Flight Procedures Cover Page	Task Action: Abbreviated Amendment	Task Type: Textual DP	Estimated Chart Date: 06/18/2020	APWS Task ID: 0D536F3945B74FBEB11059FD3EA7EFBA	APWS Request ID: C5F09347AF0C4C42821EAC70F8742028
Procedure: ATQASUK, AK PATQ ORIG-A		Enroute: NO	Specialist: Kretschmer, Jason		Agreement Number:
Airport ID: PATQ	Airport Name: ATQASUK EDWARD BURNELL SR MEMORIAL		Airport City: ATQASUK		State: AK
Facility ID:	Facility Type:	Flight Inspection Remark Type:			
<p>Procedure Comments:</p> <p>PENDING DATA USED FOR AIRPORT AND RUNWAY (05-21-2020).</p> <p>RUNWAYS RE-NUMBERED. MV UPDATED FROM 20 EAST/2005 EPOCH YEAR TO 13 EAST/2020 EPOCH YEAR.</p> <p>PROCESSED IAW AIRCRAFT OPERATIONS GROUP (AJW-33) MEMO, OCTOBER 3, 2018, SUBJECT: FLIGHT INSPECTION REVIEW NOT REQUIRED.</p> <p>CONTACT JOHN BORDY, AJV-A422, 405.954.0980.</p>

PATQ
ATQASUK EDWARD BURNELL SR MEMORIAL
ATQASUK, AK
DEP RWY 7, ORIG-A
1:100,000

Federal Aviation Administration Categorical Exclusion Declaration

Procedure Name(s): RNAV (GPS) RWY 7 RNAV (GPS) RWY 26 Textual ODP (Standard)

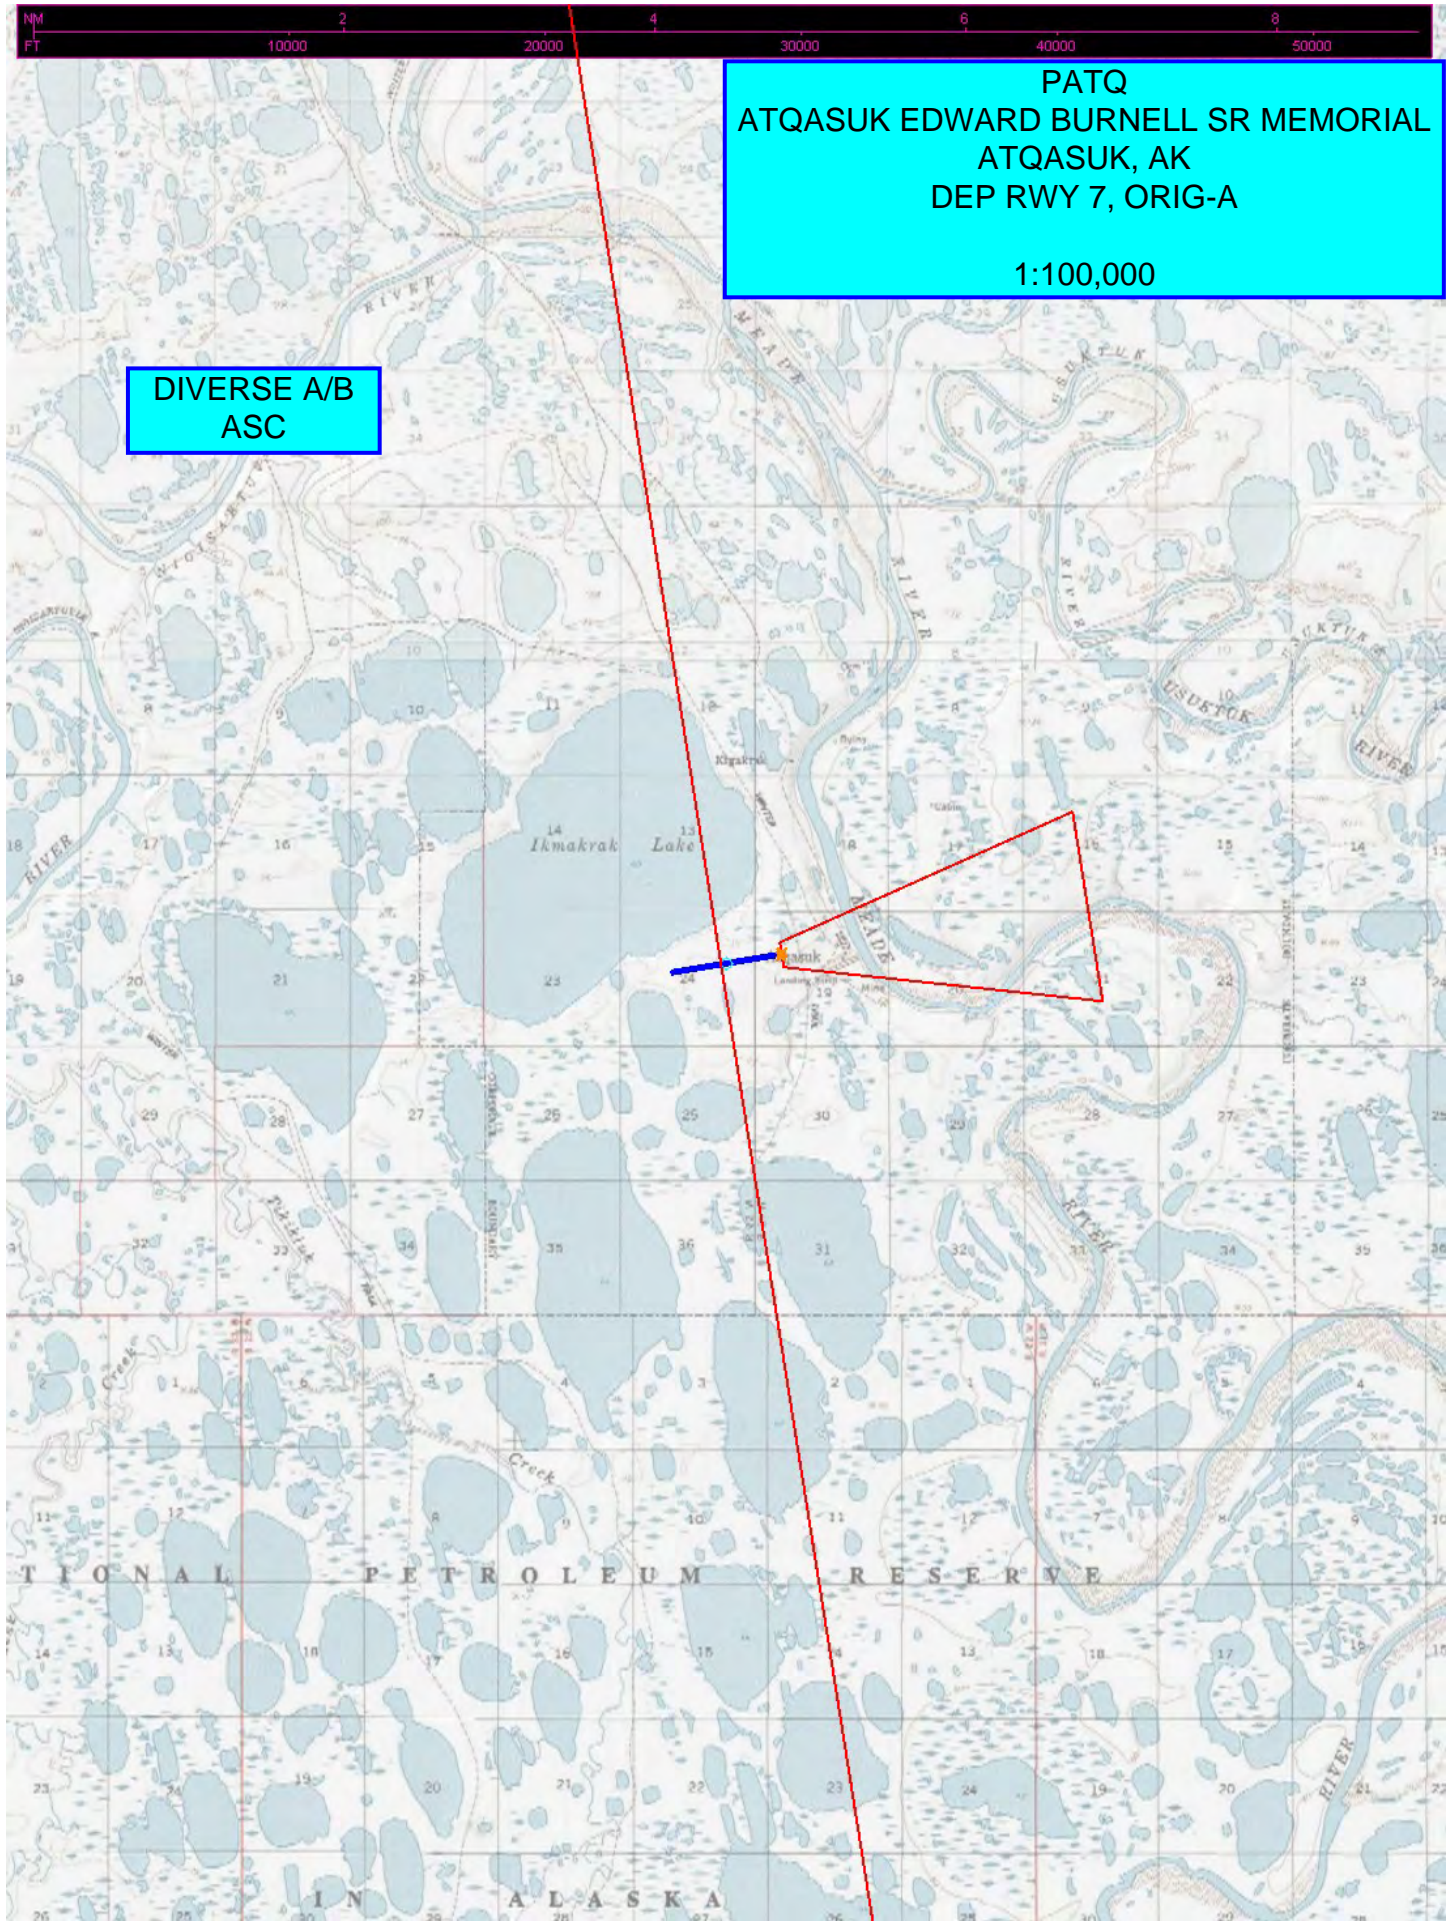
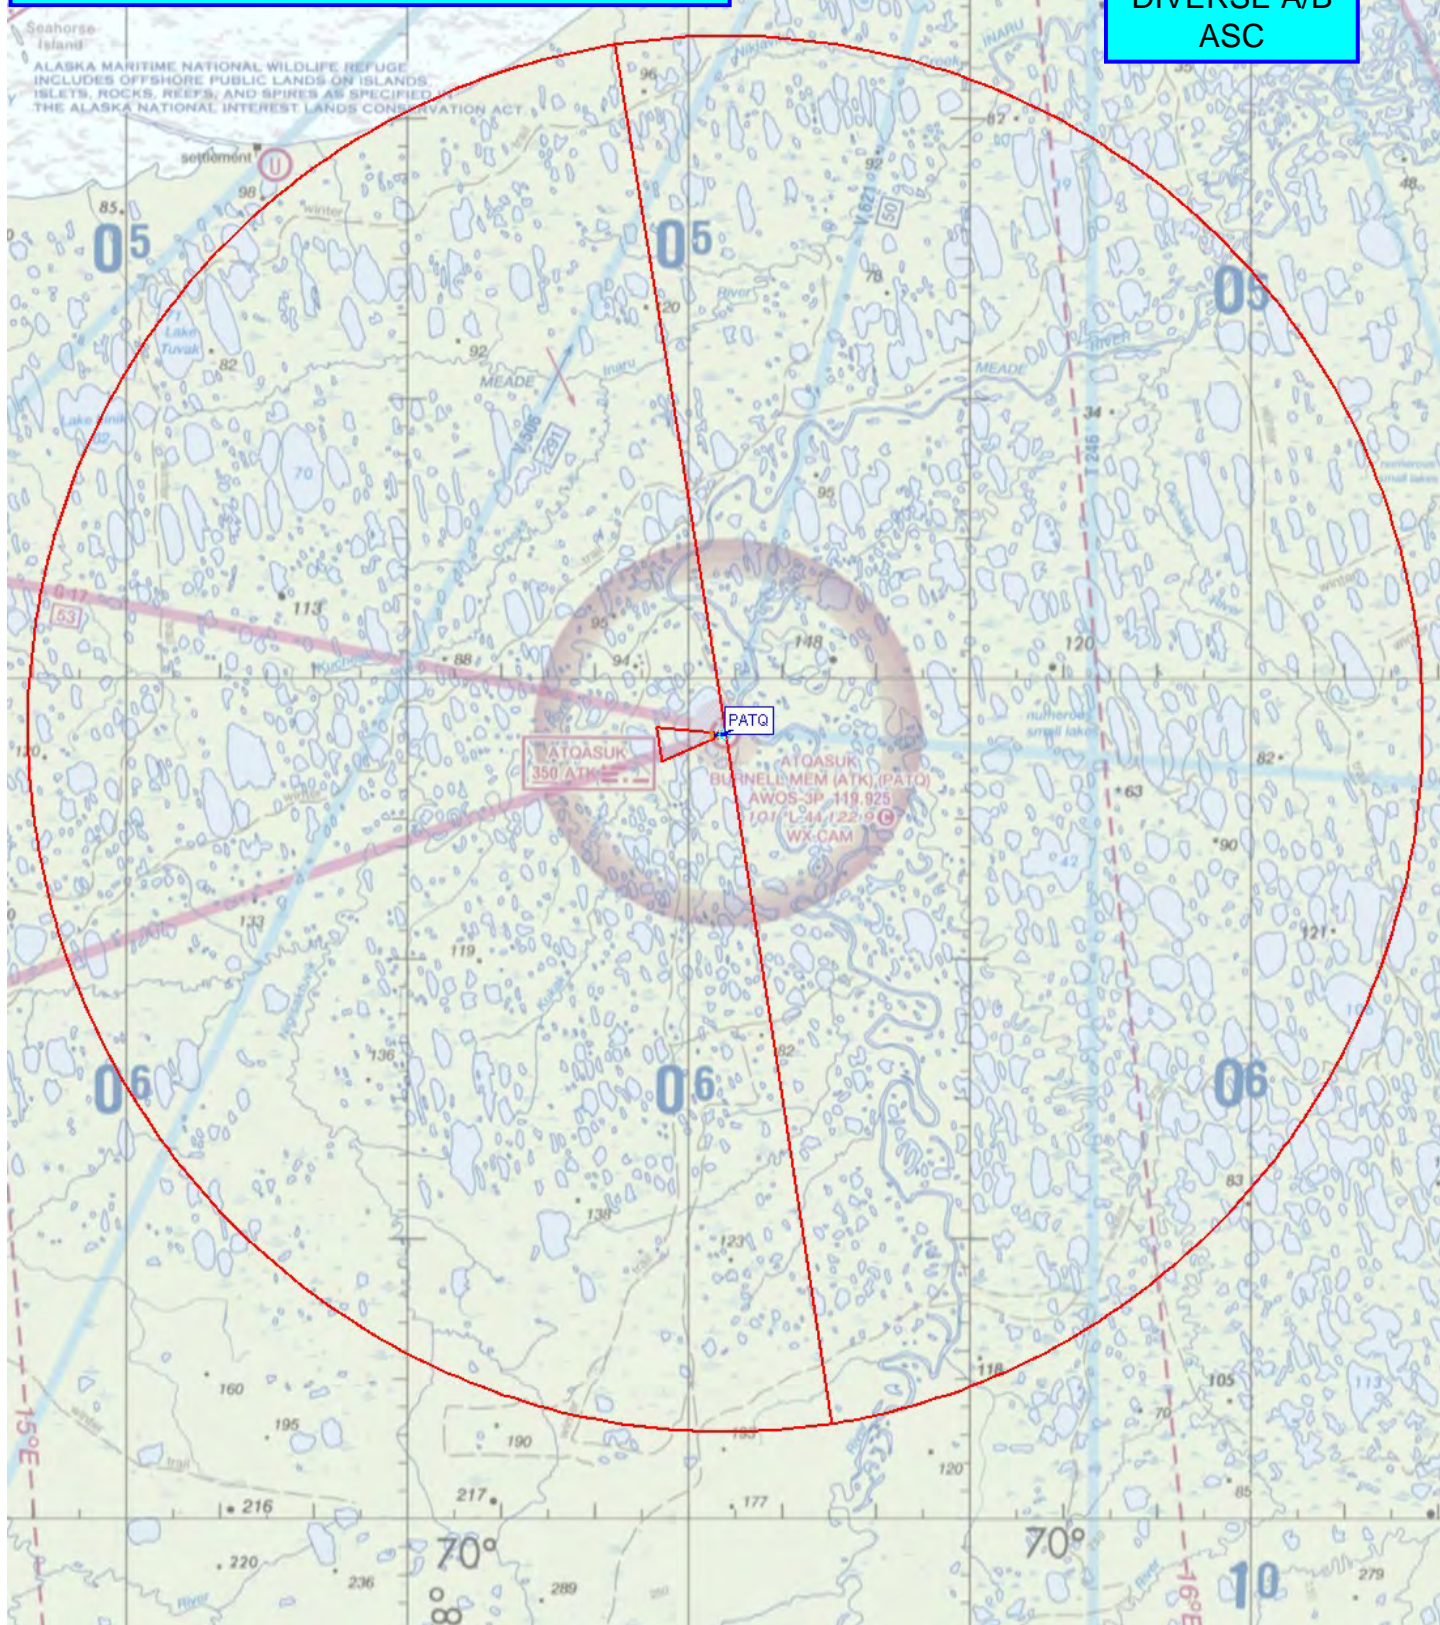
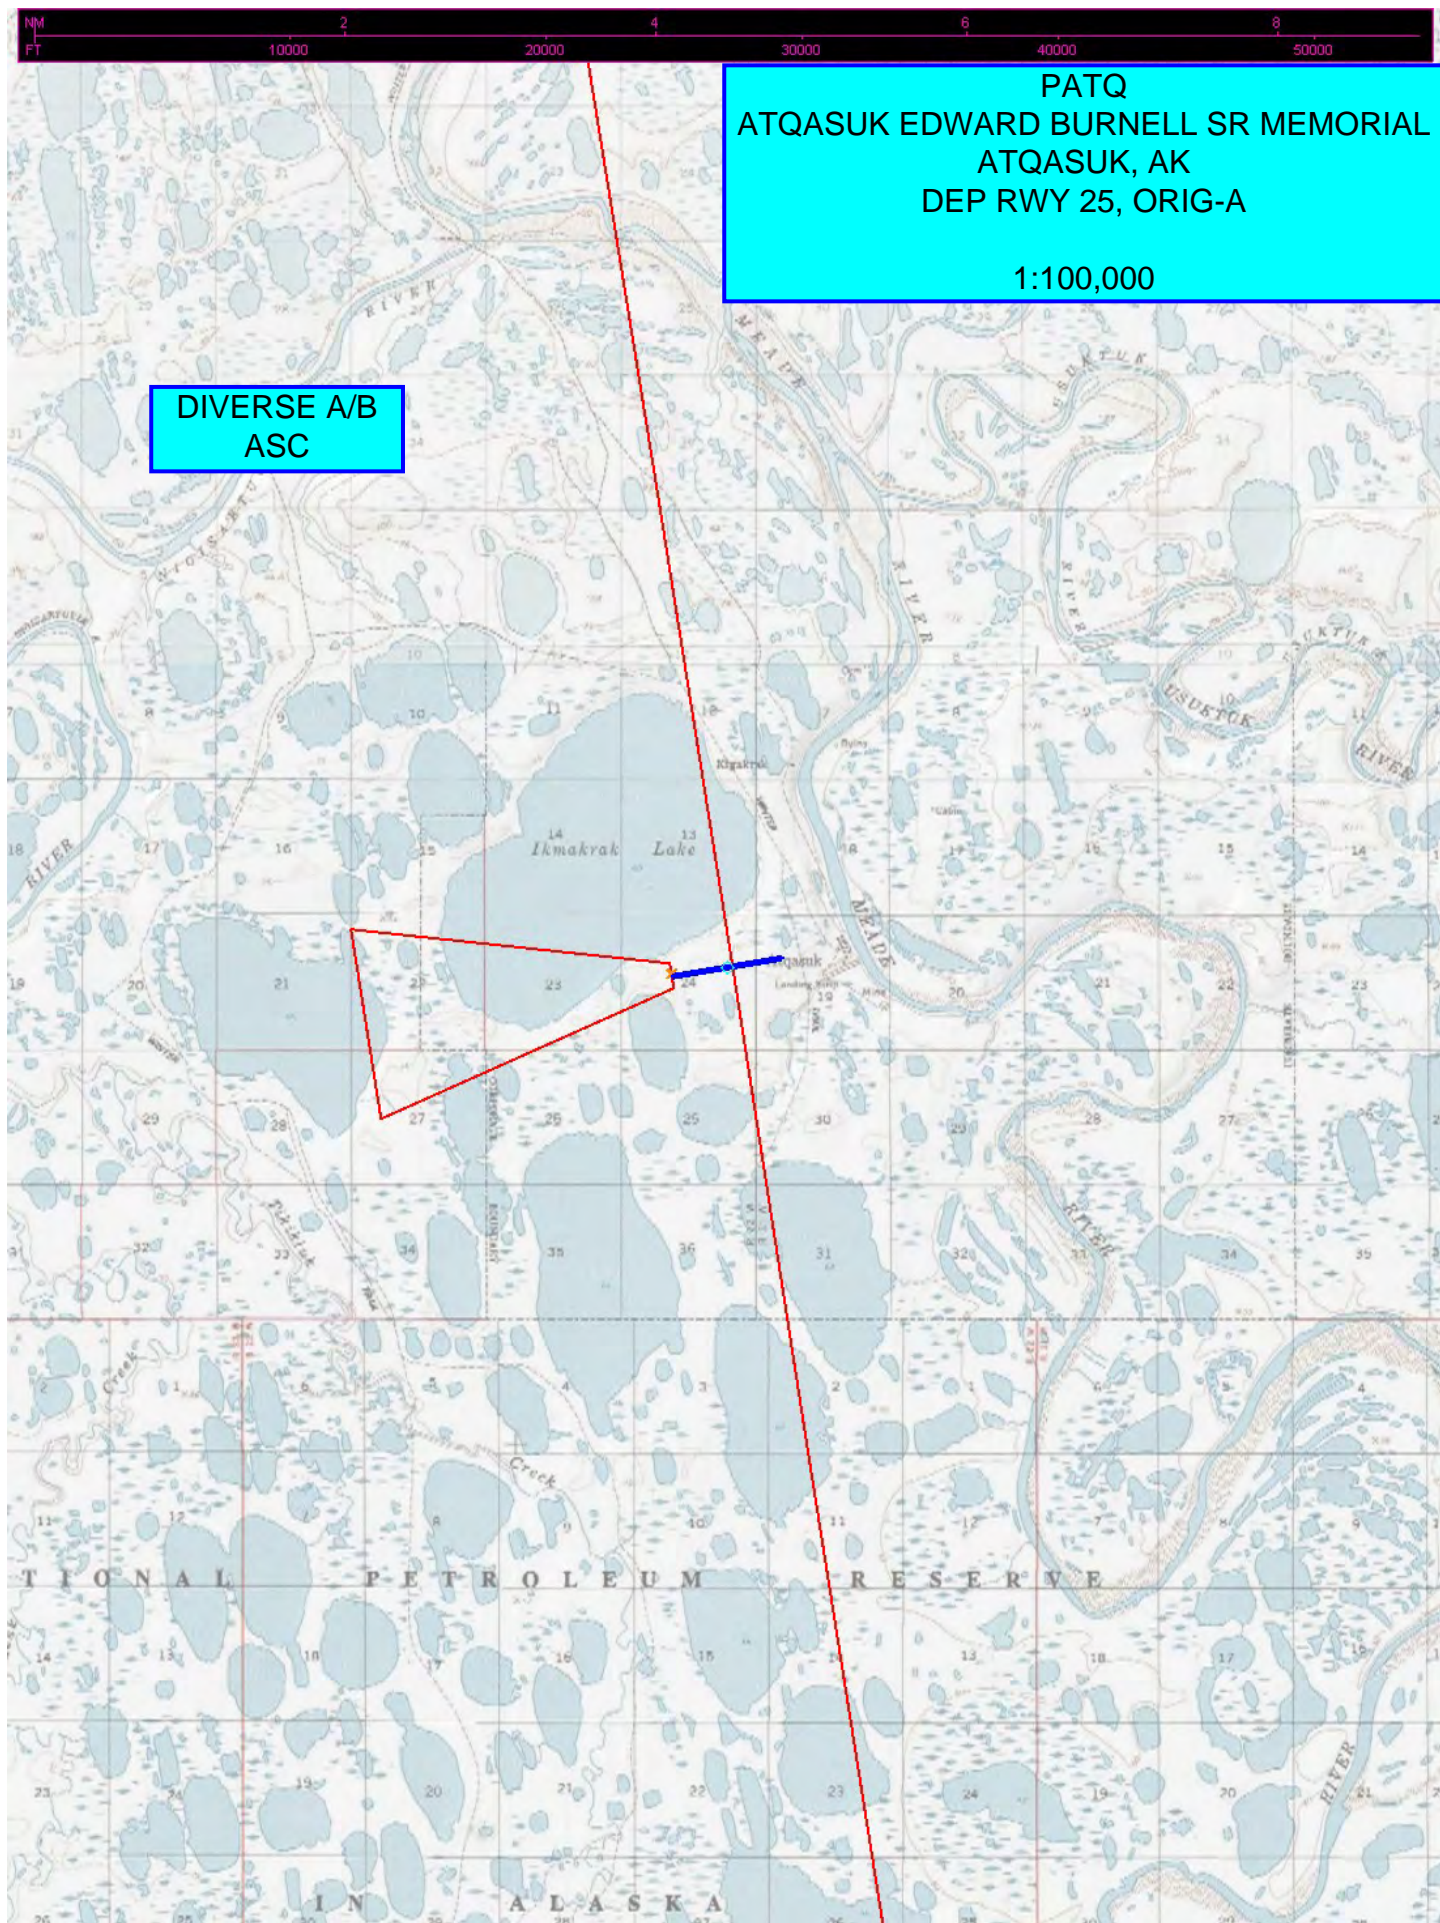
Runway renumbering for magnetic variation update (2005/E20 to 2020/E13): Runway 6 will be renumbered as Runway 7. Runway 25 will be renumbered as Runway 26.

Update runway numbers on textual obstacle departure procedure instructions.
